Design Revision 02

Building: Naval Station Norfolk, VA Waterfront

Project Title: FY25 / FY26 Maintenance Dredging @ Naval Station, Norfolk

Date: 13 August 2025

SHEET NO.		NAVFAC DRAWING NO.	SHEET TITLE
NO.	SHEET		
GENERAL			
2	V-002	12.919.176	DETAIL SHEET

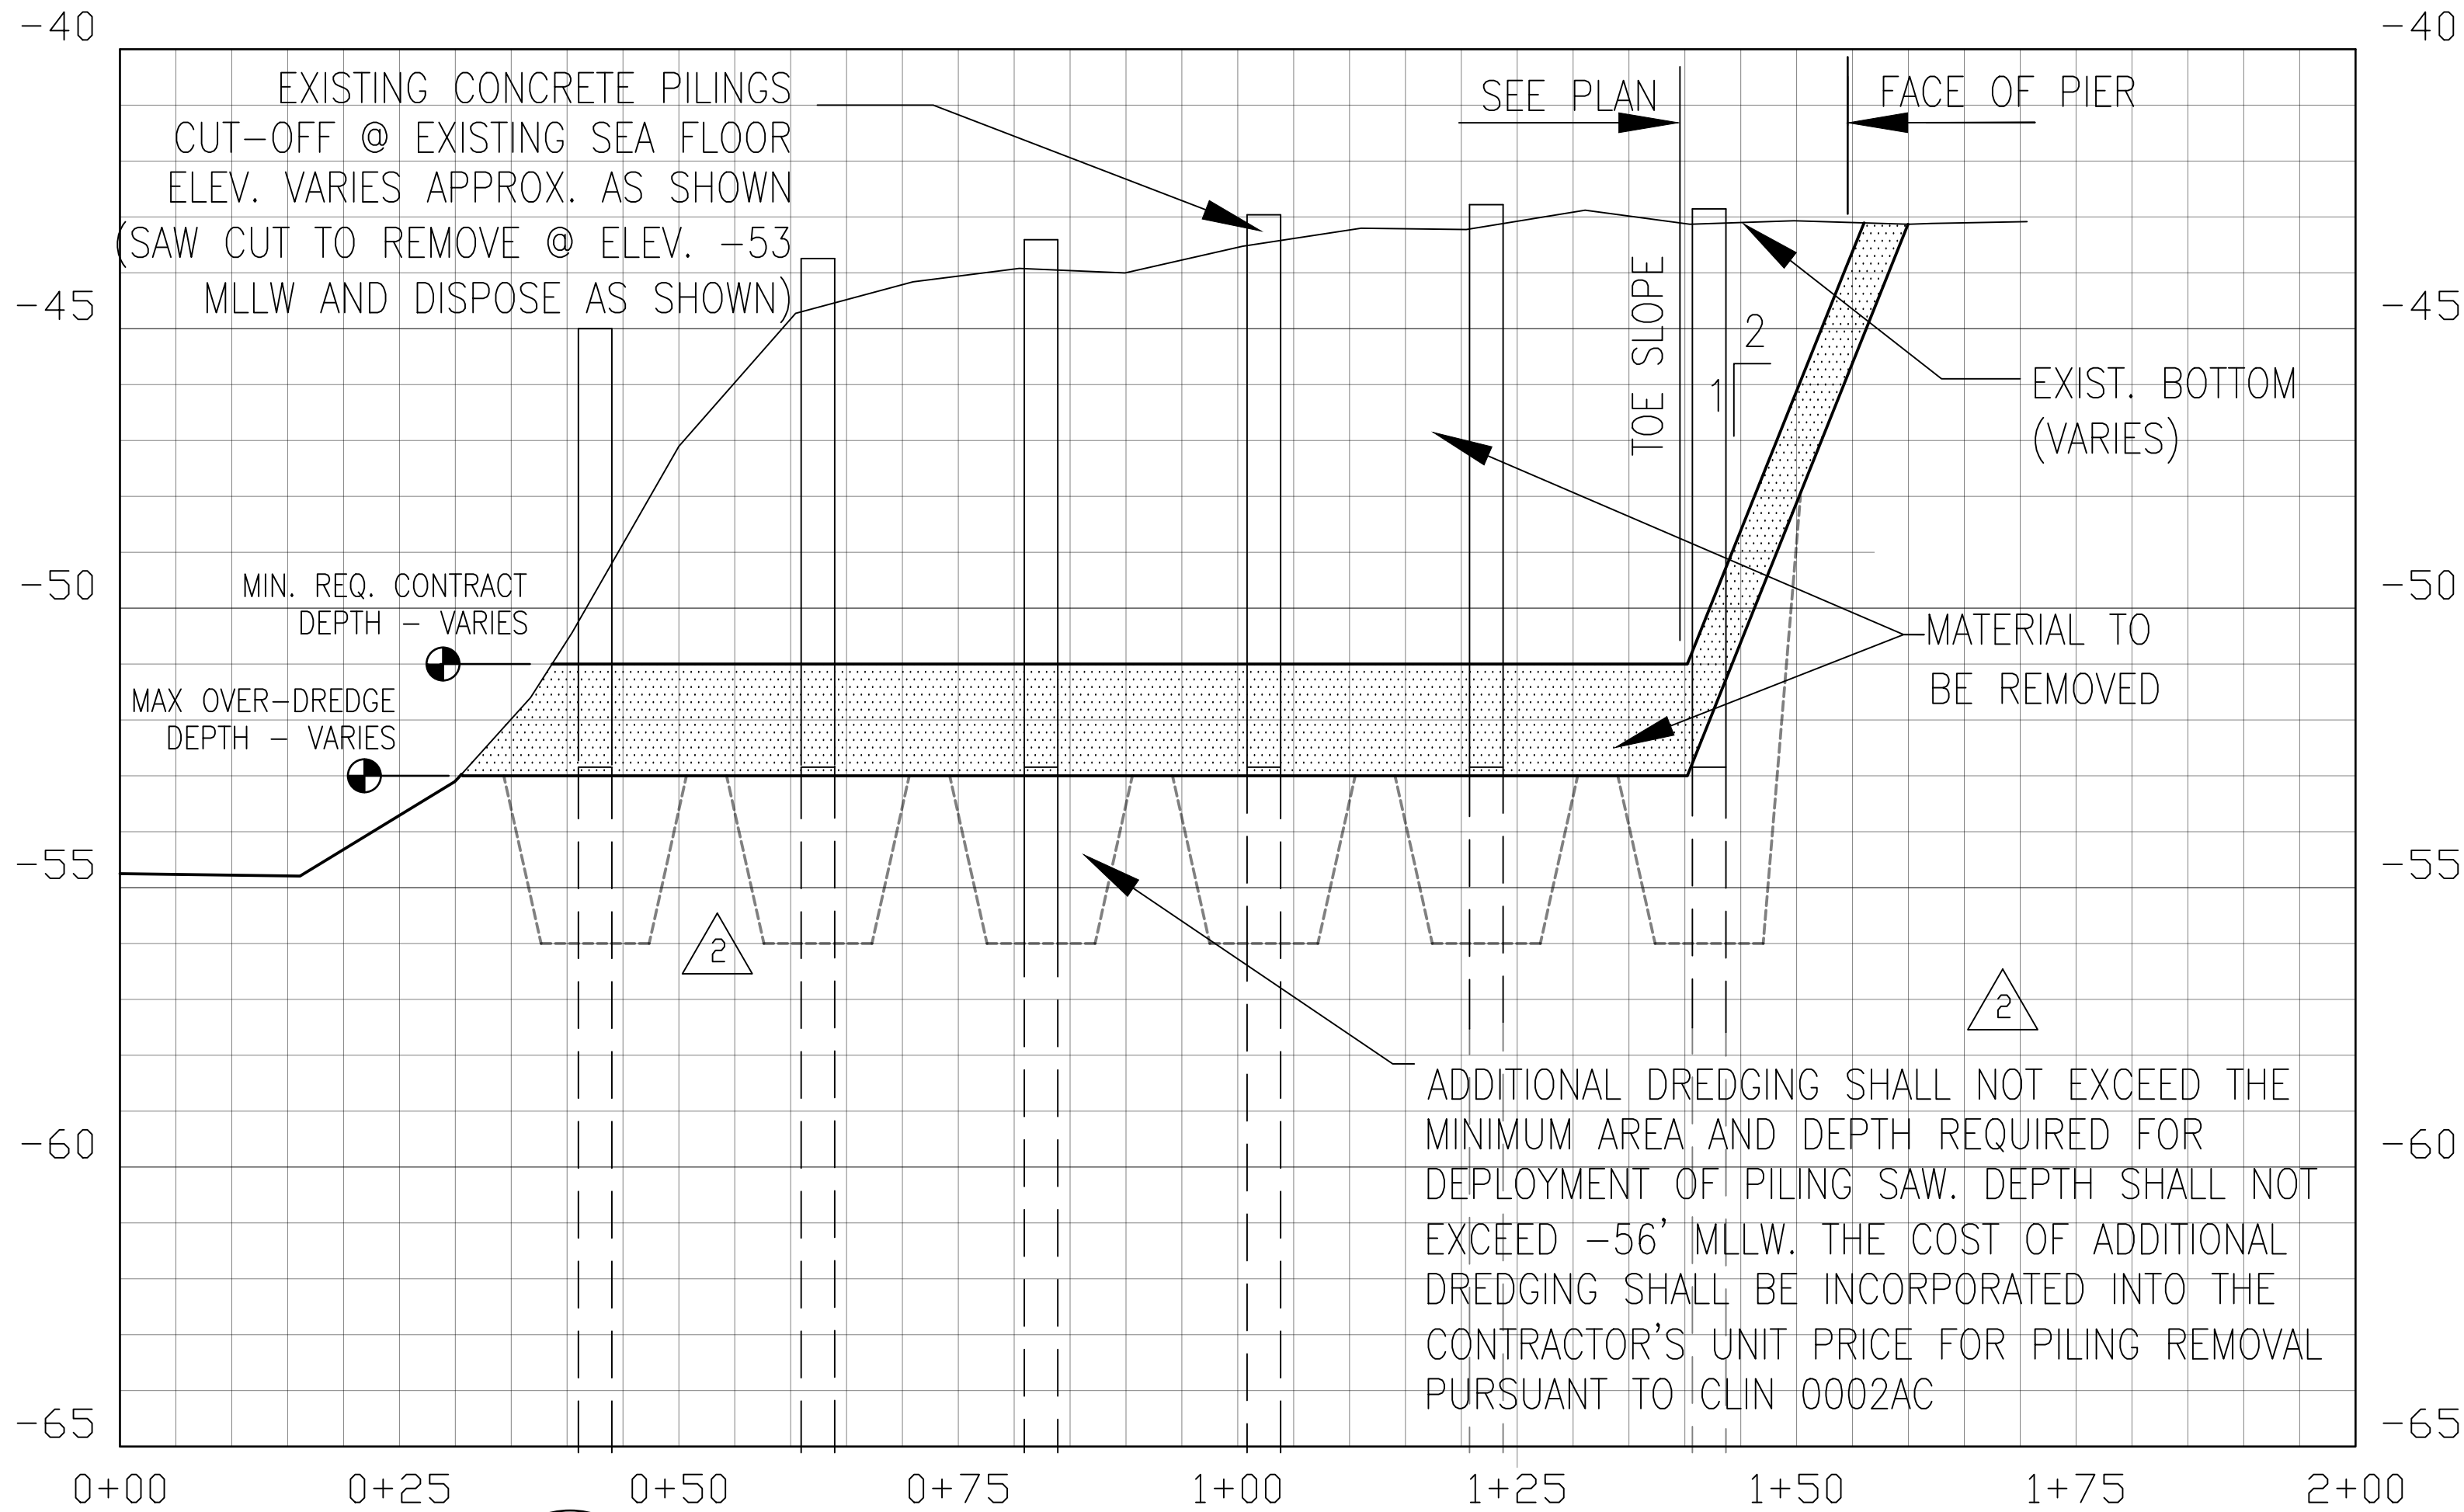
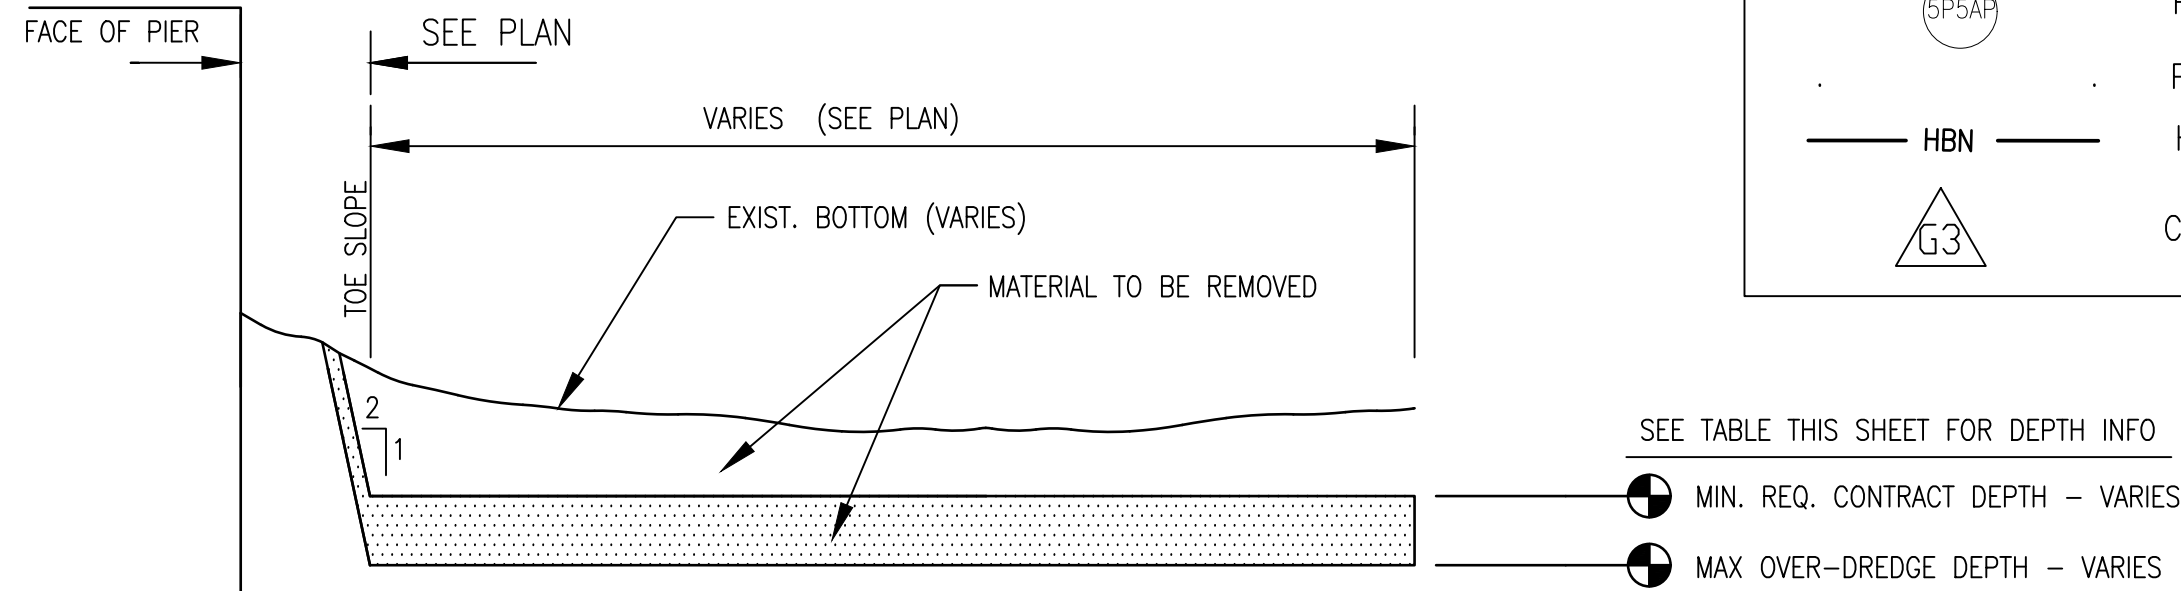
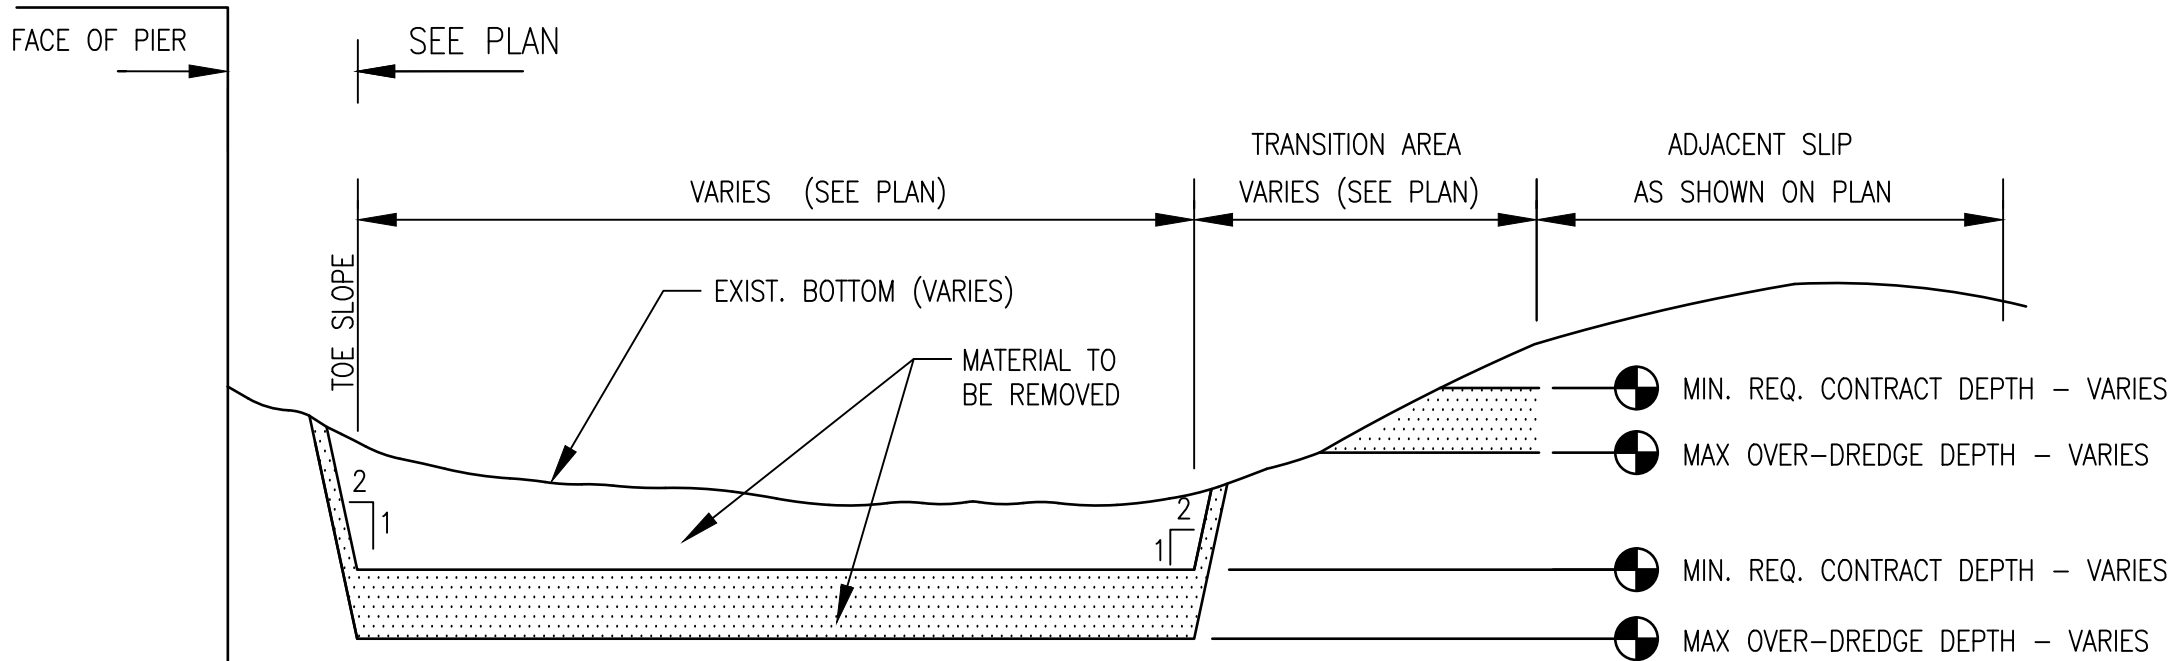
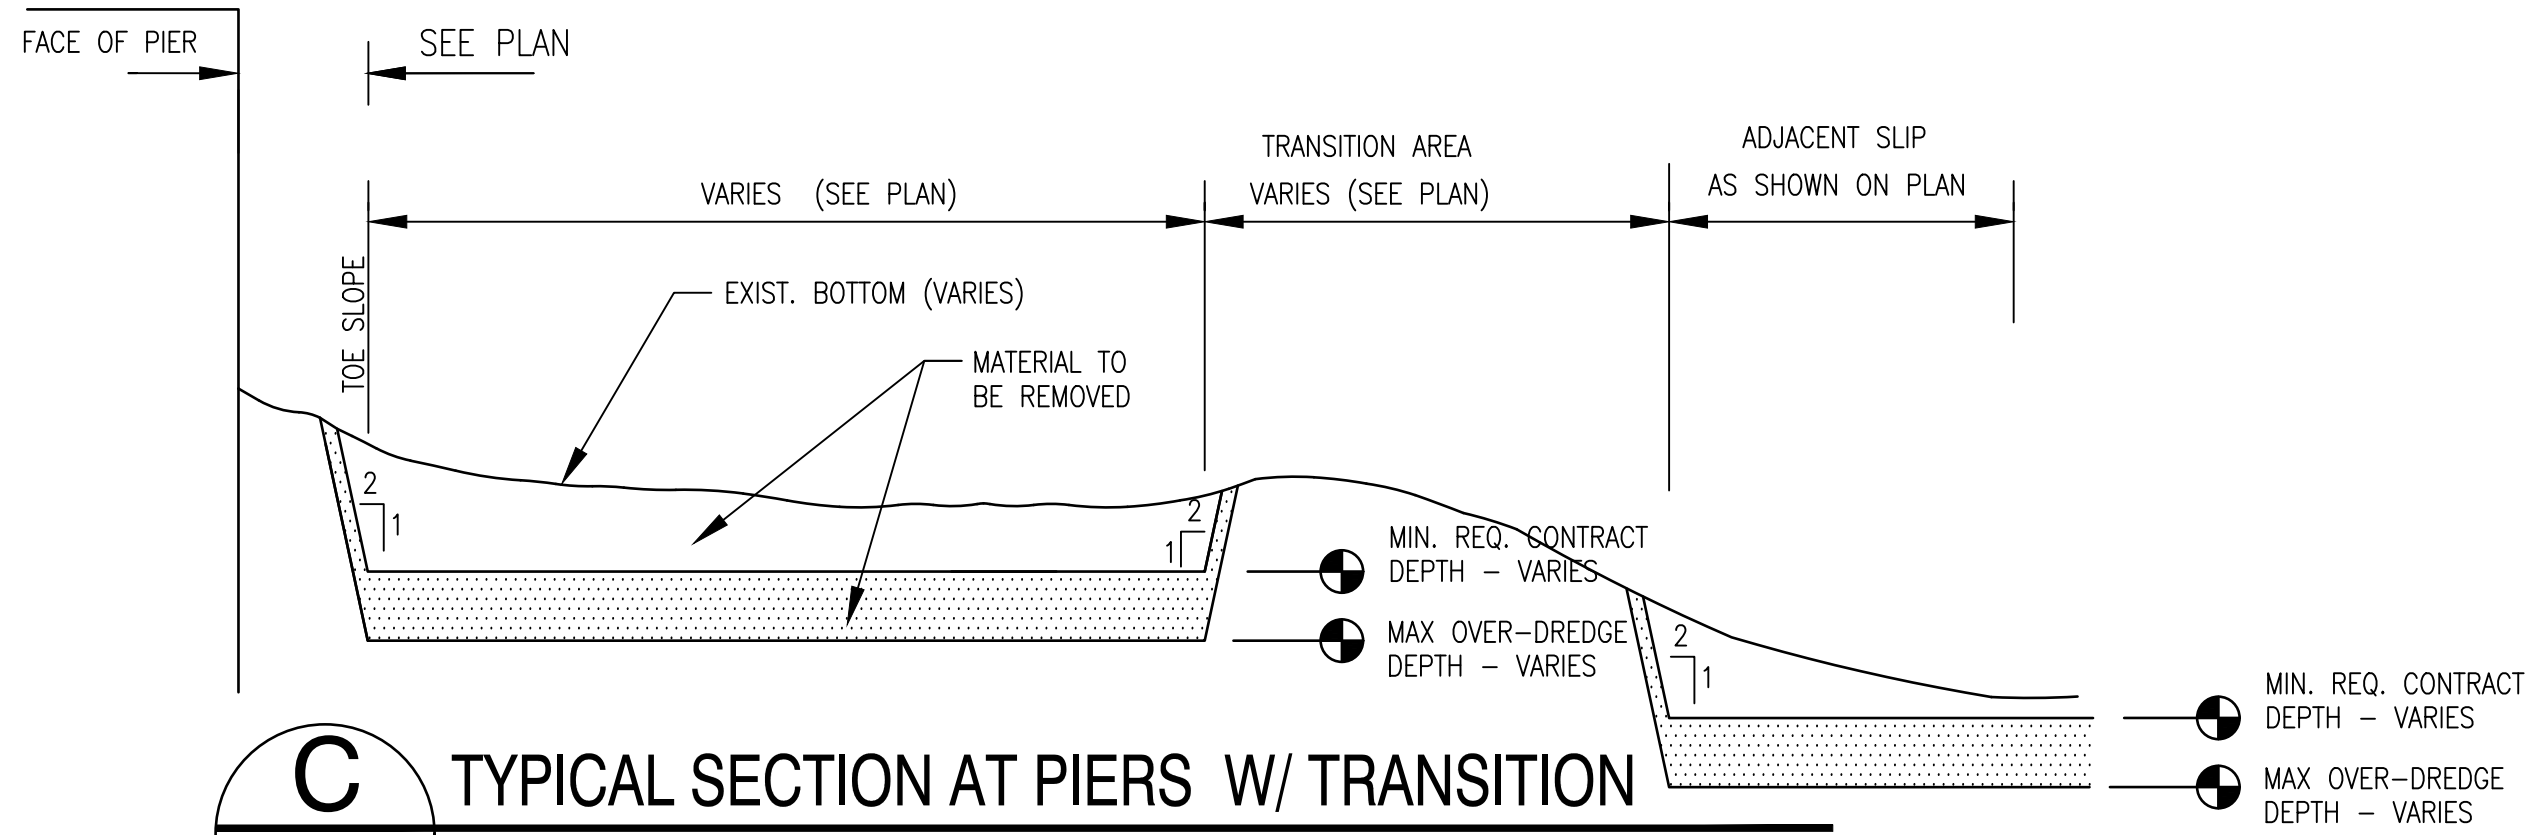
1. Corrections to Contract Documents in Responses to PPIs.
2. Revised Bid Schedule.
3. Additional Information on Existing Conditions @ Pier 11 North Tee.
